Bay Campus, Building 20 & Townhouses

Flood Risk Technical Note

This Technical Note (TN) has been prepared in support of the reserved matters approval application (reference: P2019/0014) which seeks approval of purpose built student accommodation in Building 20 and two standalone townhouse blocks at Swansea Bay Campus.

Figure 1: Typical cross section of rock revetment (refer to plan for scale drawing/detail)

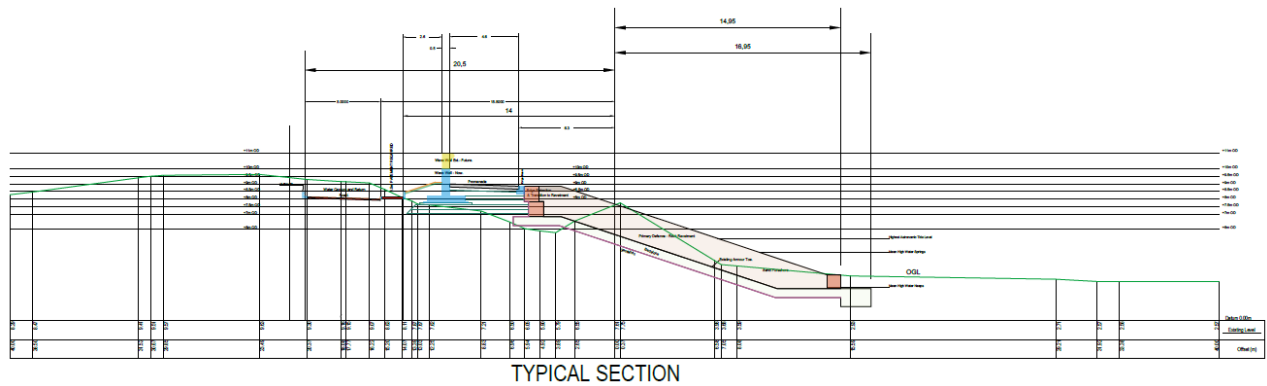
The plan shows a red line boundary (Figure 2) and reference should be made to the geometry of the landward red line which forms the interface between the coastal defence and the Townhouses development. Figure 1 shows a typical cross section of the rock armor and Figure 3 details the proposed and more focused cross section of the seaward road between the northern back edge of the revetment and the pavement to the south of the proposed townhouses development. Attention is directed towards the 'water capture and return road' and the threshold level on the landward boundary of +8.45m OD. The designated area for coastal protection is therefore separated from the Townhouse development by a boundary set at a threshold level of +8.45m OD.

It is important to appreciate that the coastal defence has no bearing and is not directly impacted by tide. The principal function of our sea defence is to deal with wave action and the potential for wave overtopping. Waves obviously exist in water and wave height / wave energy is governed by water depth which leads us back to tides. Tides at the Bay Campus site could never reach a height which would cause an influx of water to the landward side of the defence. Tides could, however, reach a height on the seaward side that, whilst being well below the crest of the defence, would allow waves of sufficient height to exist at the defence and that could cause overtopping. Overtopping would not be produced by the action of waves breaking over the crest but rather being translated into runup which would cause water to spill over the crest at a limited rate. The conditions for significant overtopping would be statistically rare and subject to the joint probability of an extreme event applying to both variable events, such as tides and storms. It is worth noting that the threshold level of the defence is +10mOD which is 3m above the minimum permitted site level referred above.

The criteria which determines the design of the defence to protect against waves effectively eliminates the risk of tidal inundation.
